Appoquinimink School District

TO: ALL OFFERORS
FROM: Keith Hopkins
Construction Projects Manager
SUBJECT: ADDENDUM # 4: ASD-BMECC

**APPOQUINIMINK SCHOOL DISTRICT
BRICK MILL EARLY CHILDHOOD CENTER
380 BRICK MILL ROAD
MIDDLETOWN, DE 19709**

Specifications and/or Drawings for
Brick Mill Early Childhood Center - #2001
Appoquinimink School District

ADDITIONAL MOCK-UP PANEL
ELEVATION - NOT TO SCALE

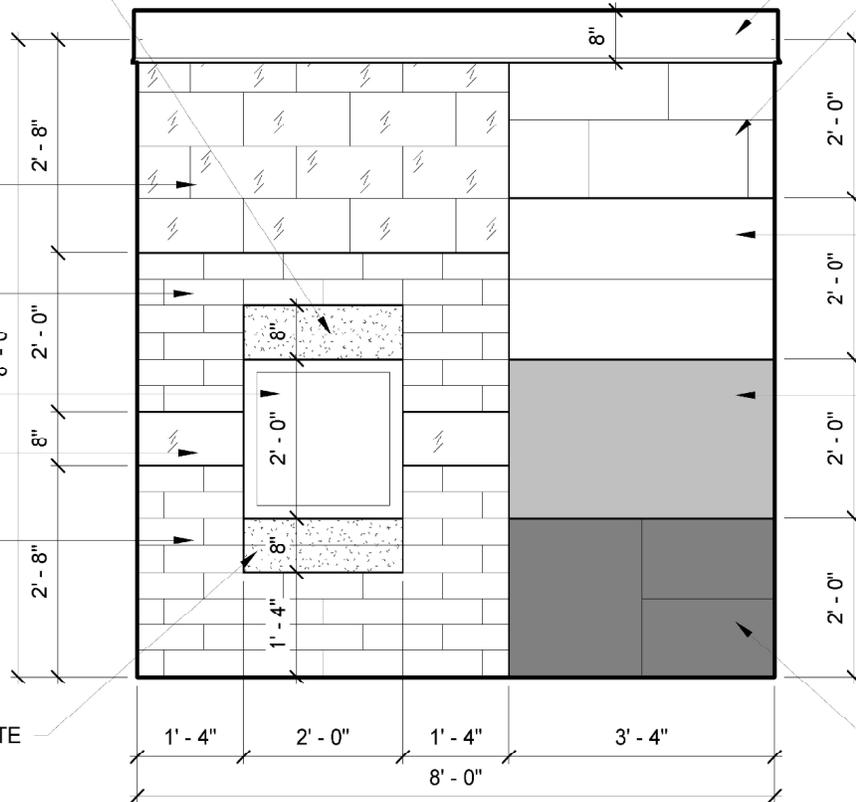
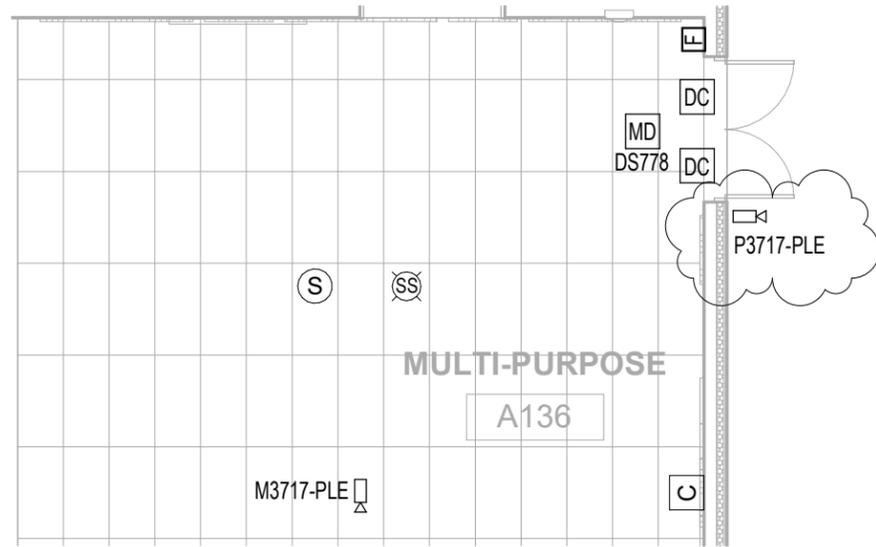
- 2.2 See updated Sketch to include exterior mockup. The following trades are required to install mockup as detailed; concrete, framing, masonry, spray foam, window, metal panels, and roof coping.
- 2.3 See Architect's Narrative for Drawing Changes
- 2.4 See Architect's Narrative for Specification Changes

- Item D2-1 Drawing A5.1 – OVERALL EXTERIOR ELEVATIONS
Add Mock-Up Panel Elevation 6/A5.1. Refer to sketch SK-A-002.

SK-E-01

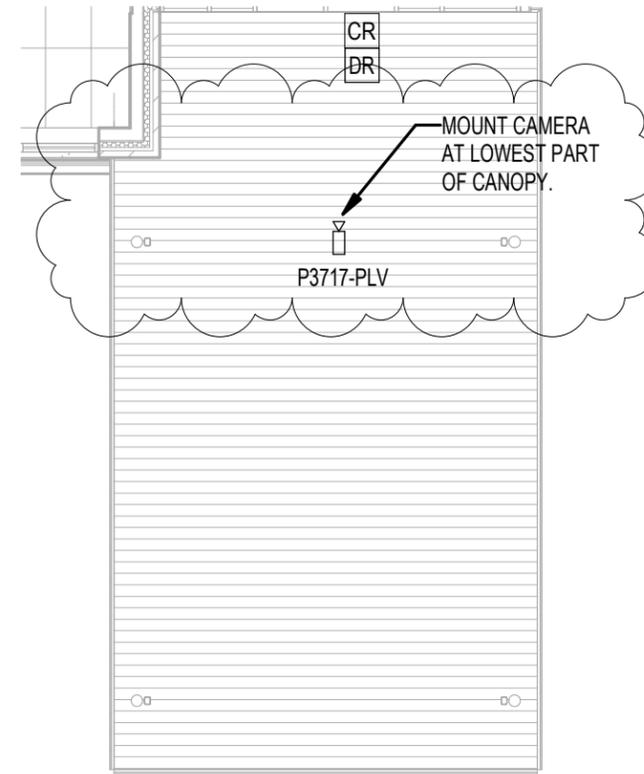
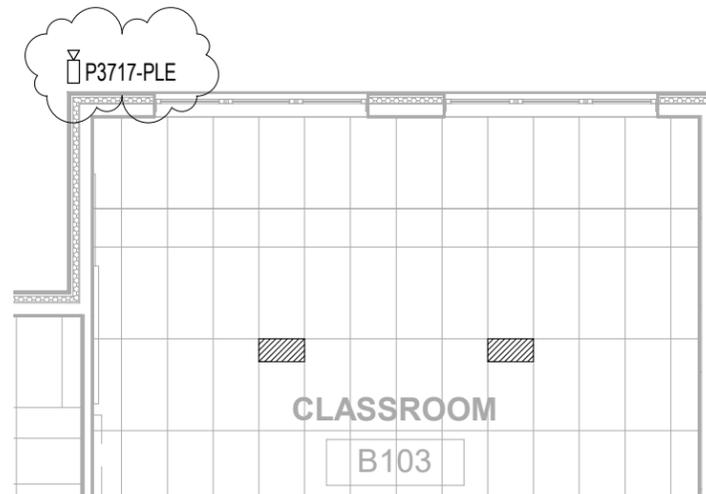
- Item D2-4 Drawing E3.7, PARTIAL FIRST FLOOR SPECIAL SYSTEM PLAN – AREA ‘A’
 - a. CHANGE exterior camera at Multi-Purpose A136 and main lobby canopy to P3717-PLE. Refer to attached Sketch SK-E-01.
 - b. MOVE/CHANGE main lobby canopy camera to P3717-PLE. Refer to attached Sketch SK-E-01.

- Item D2-5 Drawing E3.8, PARTIAL FIRST FLOOR SPECIAL SYSTEM PLAN – AREA ‘B’
 - a. CHANGE exterior camera at Classroom B103 to P3717-PLE. Refer to attached Sketch SK-E-01.
